SUNDRY NOTICES AND REPORTS ON WELLS
Do not use this form for proposals to drill or to re-enter an abandoned well. Use form 3160-3 (APD) for such proposals.

Raven Federal #1

RE-COMPLETION PROCEDURE

**Raven Federal 1
30-025-40465
Apache Corporation
June 06, 2013
Conditions of Approval**

Apache Corp.
Proposed Wellbore

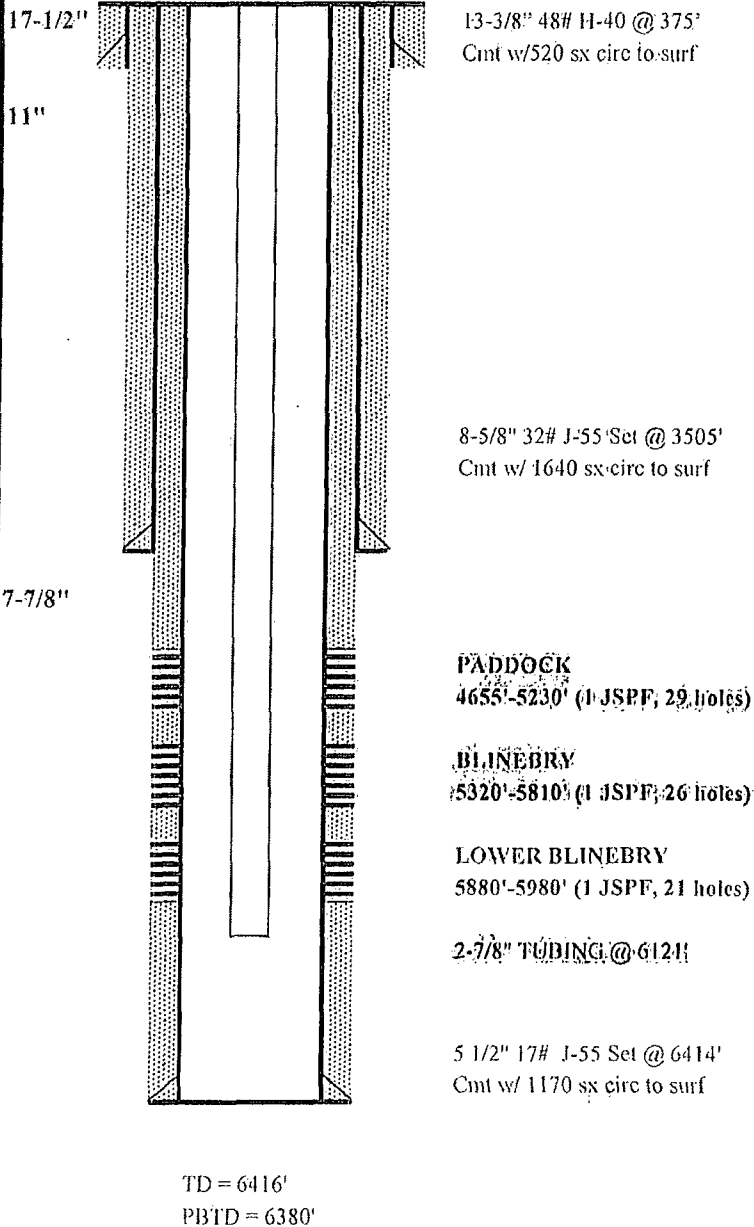
- 1. Must conduct a casing integrity test to maximum treating pressure before any work can be done. Submit results to BLM. The CIT is to be performed on the production casing per Onshore Oil and Gas Order 2.III.B.1.h. Submit results to the BLM.**

- 2. Recompletion procedure approved as written.**
- 3. Operator has been approved for this zone, Cedar Lake; Gloreita-Yeso (pool code 96831) which includes the Paddock and the Blinebry, so no NOI is necessary only a subsequent report is needed after pay has been added.**

10. Subsequent sundry required detailing work done and completion report with both formations. Operator to include well bore schematic of current well condition when work is complete.
